Attachment B
Errata Memorandum

Brightline West Cajon Pass High Speed Rail Project Environmental Assessment

Errata Memorandum

Federal Railroad Administration (FRA), December 2022

Proposed Hesperia Station Land Use Map Brightline West Cajon Pass High-Speed Rail Victor Valley to Rancho Cucamonga, San Bernardino County, California

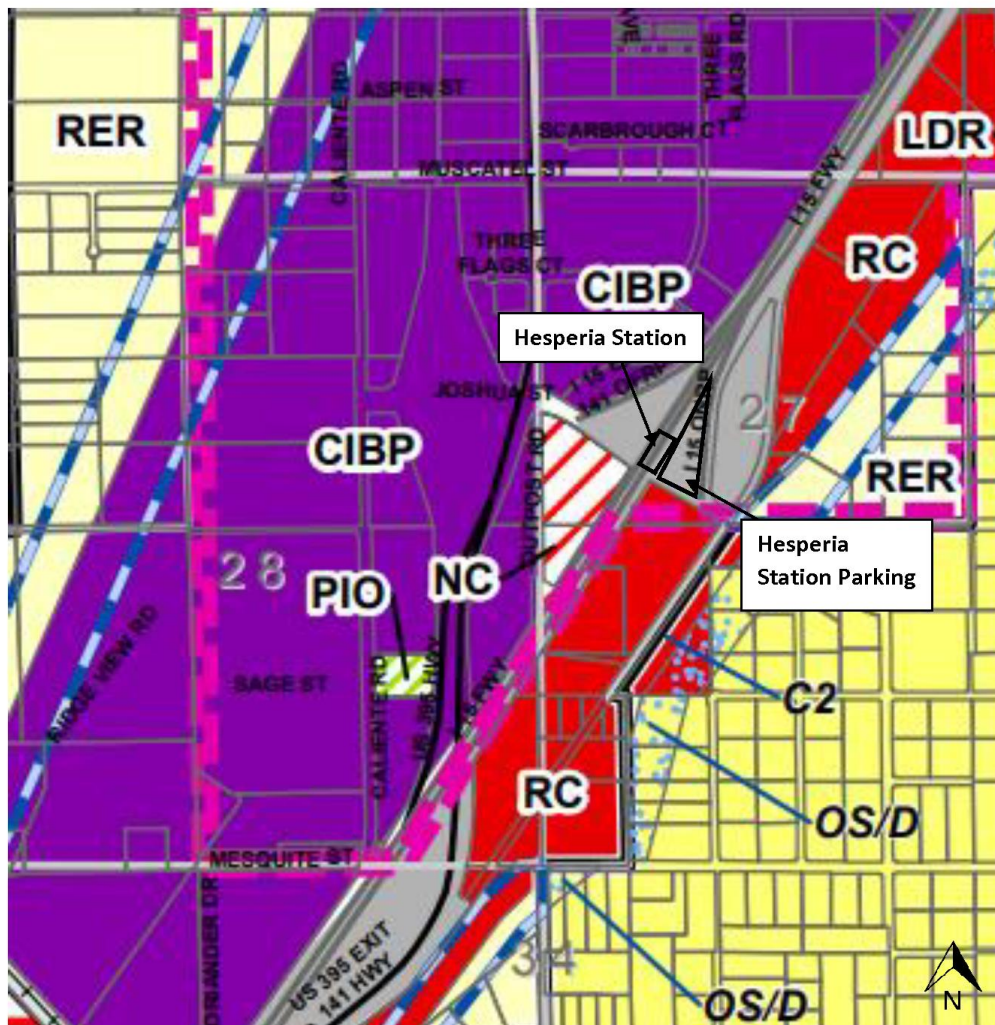
In Section 4.8.4, Affected Environment, the following revisions are made to Figure 12:
